Sunset Garden Senior Living Apartments

SITE PLAN 236 UNITS

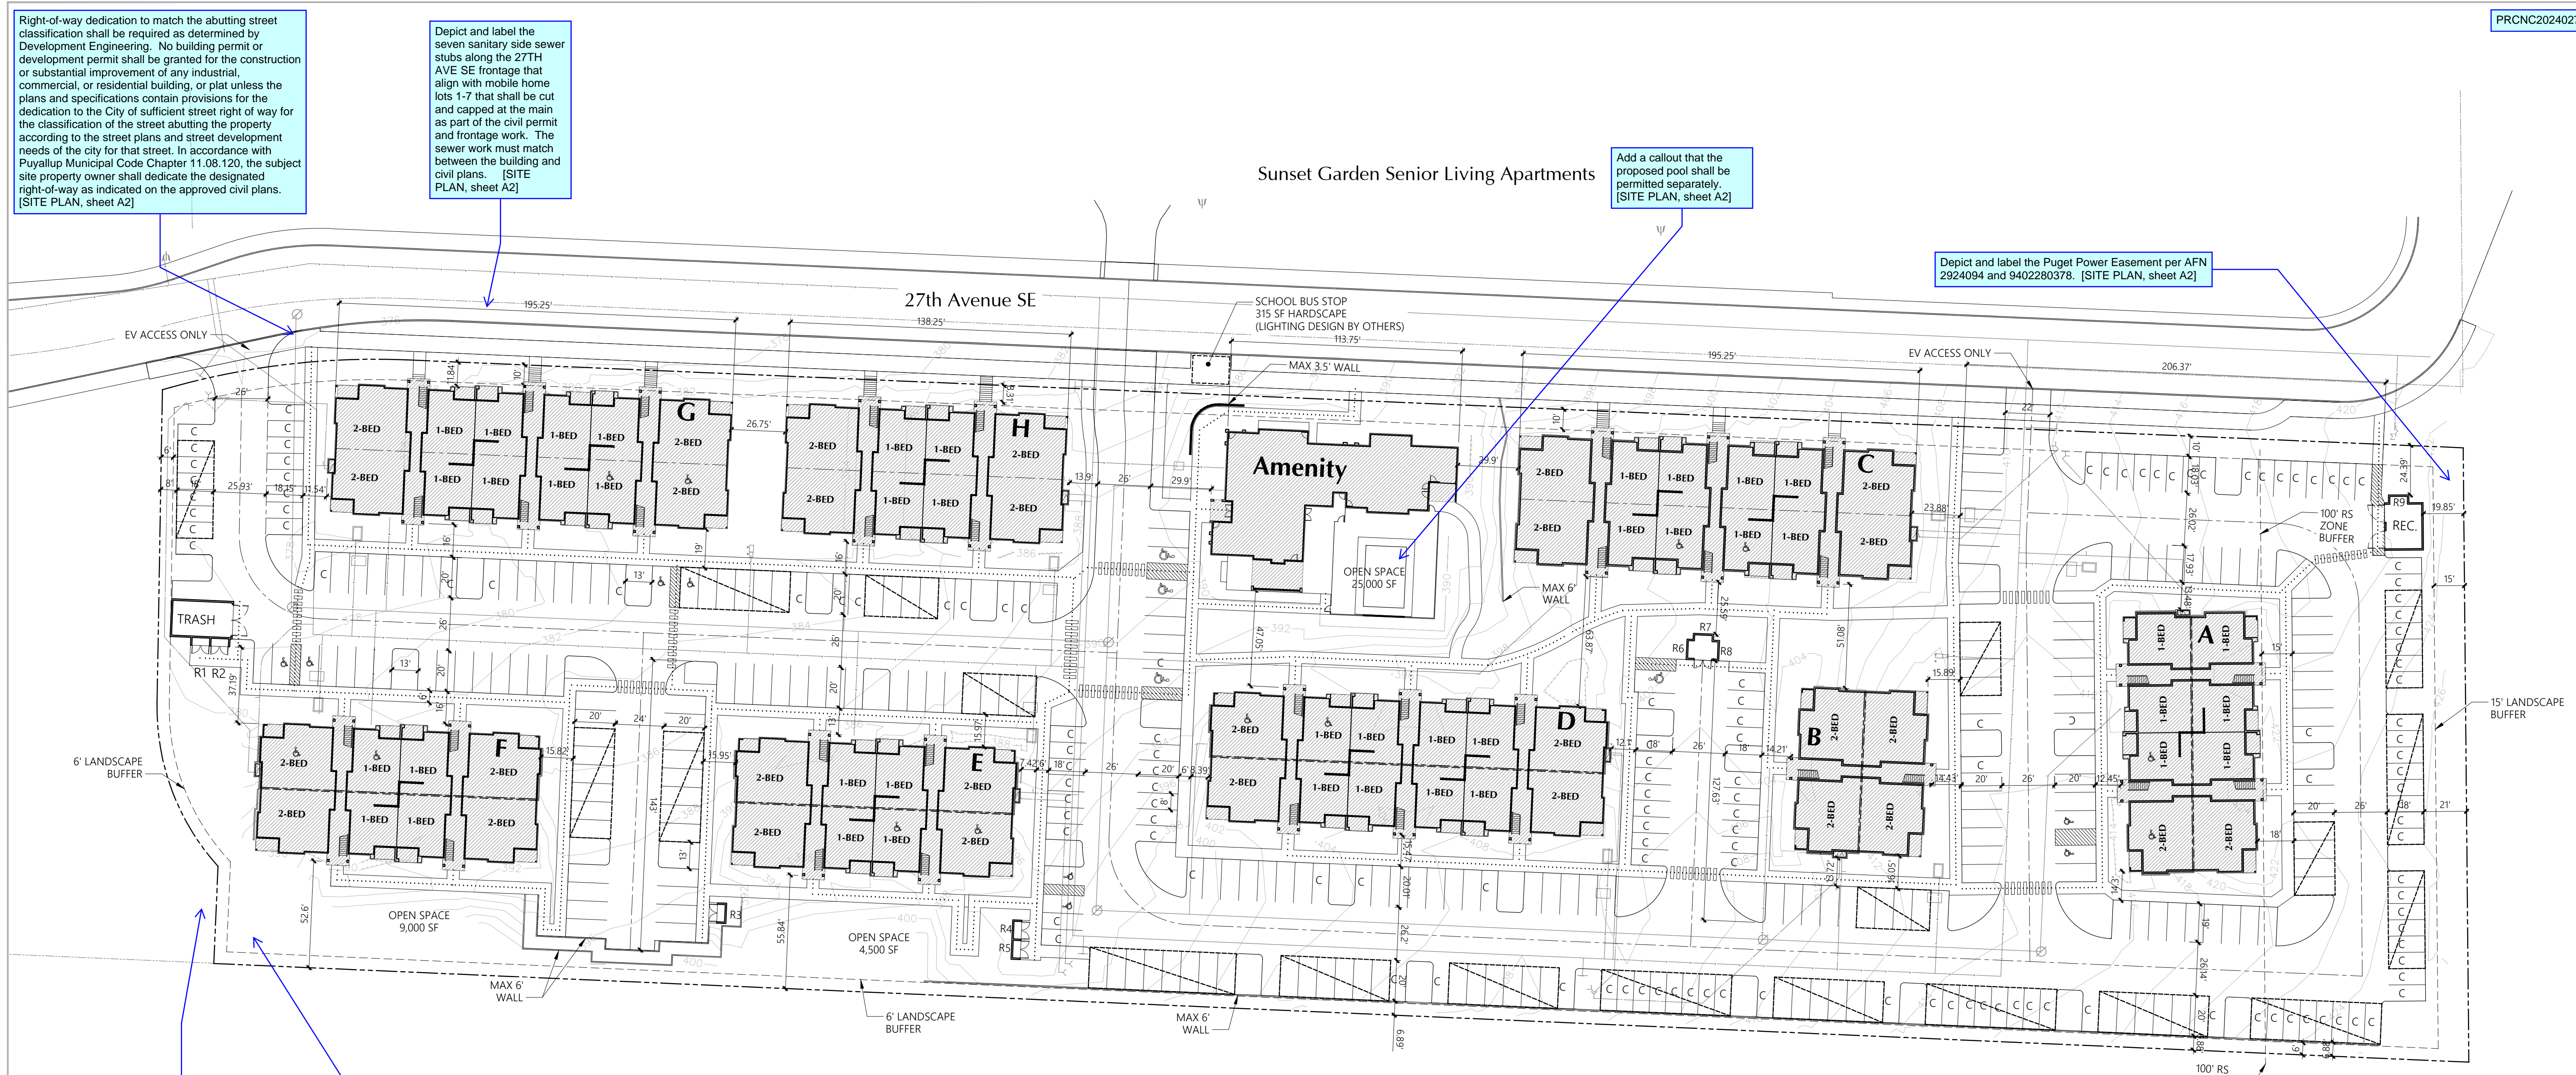
Right-of-way dedication to match the abutting street classification shall be required as determined by Development Engineering. No building permit or development permit shall be granted for the construction or substantial improvement of any industrial, commercial, or residential building, or plat unless the plans and specifications contain provisions for the dedication to the City of sufficient street right of way for the classification of the street abutting the property according to the street plans and street development needs of the city for that street. In accordance with Puyallup Municipal Code Chapter 11.08.120, the subject site property owner shall dedicate the designated right-of-way as indicated on the approved civil plans. [SITE PLAN, sheet A2]

Depict and label the seven sanitary side sewer stubs along the 27TH AVE SE frontage that align with mobile home lots 1-7 that shall be cut and capped at the main as part of the civil permit and frontage work. The sewer work must match between the building and civil plans. [SITE PLAN, sheet A2]

Add a callout that the proposed pool shall be permitted separately. [SITE PLAN, sheet A2]

Depict and label the Puget Power Easement per AFN 2924094 and 9402280378. [SITE PLAN, sheet A2]

Depict and label the US West Easement per AFN 9205140289 and 9402280378 if located on the subject site. [SITE PLAN, sheet A2]

Depict and label the PNW Bell Easement per AFN 89014180382 and 9402280378. [SITE PLAN, sheet A2]

No EV parking calculations included in parking summary. Provide EV parking to meet Section 429 of the 2018 IBC WA Amendment. Page A2 - Site Plan

Incomplete site plan. Please refer to the CoP Site Plan Standards (available to download in the permitting portal). Revise the site plan to include items 1-3 and items A-X of the City's Site Plan Standards. Since the building permit cannot be issued until civil construction permit is issued first and the building plans must match the approved civil plans, please coordinate your final building permit submittal with the approval of the civil permit to avoid redundant or surplus building permit submittals and fees. [SITE PLAN, sheet A2]

In accordance with Roadway Standards Section 100, Table 100-1 Note 1, right-of-way designated as residential access shall be provided with a 10-foot private utility easement and a 15-foot city utility easement reserved within and along front and rear and a 2-1/2-foot private and city utility easement along the side property lines of all lots abutting said residential access streets. Depict and label easements on the site plan and the provisions granting their authority, i.e. plat amendment, recording number, etc. [SITE PLAN, sheet A2]

All rock walls shall comply with City Standard Section 05.03 - Rock Walls. Any walls 4 feet or higher requires a separate City building permit. Label all site plan walls accordingly. [SITE PLAN, sheet A2]

Dumpster Enclosures shall comply with City Standard Section 208.1:

- Enclosures (with roof) shall be required for all new commercial and redevelopment projects where Minimum Requirement #1 through #5 or Minimum Requirement #1 through #9 are required, as outlined in the Ecology Manual. Enclosures shall be covered (roof) and fully enclosed to prevent precipitation from entering garbage dumpsters, containers, compactors, grease dumpsters and the enclosure floor. This does not exempt the requirement for watertight containers.

- Enclosures shall be large enough for a garbage service vehicle to pick up and dump the waste without the container being rolled outside the enclosure. The gate opening shall be a minimum of 12 feet wide and swing open a minimum of 120 degrees from the closed position. Each gate shall also include a drop rod and receiving posts to keep the gate fixed, or pinned, in the open and closed position. The vertical clearance of the roof shall be a minimum of 15 feet and the minimum depth of the enclosure shall be 12 feet.

- Where one (1) enclosure is utilized for both garbage and recycling services the gate opening shall be a minimum of 25 feet.
- Enclosures should be located within 300' of the business or residence it is serving.

- Enclosures shall be designed to allow walk-in access without having to open the main service gate.
- Enclosures for compactors shall be designed on a case-by-case basis. The enclosure width, depth and vertical clearance shall be sized and evaluated based on the compactor and the use of the business or residence.

- Enclosures should be strategically placed for accessibility and designed to accommodate the turning radius of a SU-30 single unit truck.
- A grade break shall be provided around the enclosure to prevent runoff from entering the enclosure.

- No stormwater catch basins or manholes should be located within 10 feet of the enclosure, if unavoidable the lid shall be solid and locking.
- The interior floor of the enclosure area shall slope towards a Type I catch basin, or equivalent, and be plumbed to sanitary sewer.

- Roof downspouts for enclosures shall be connected to an existing or new stormwater collection system and accounted for during design. Downspouts discharging over sidewalks and parking lots are prohibited.

- When designing garbage enclosures, developers are encouraged to contact the garbage service provider to verify the location and access. [SITE PLAN, sheet A2]
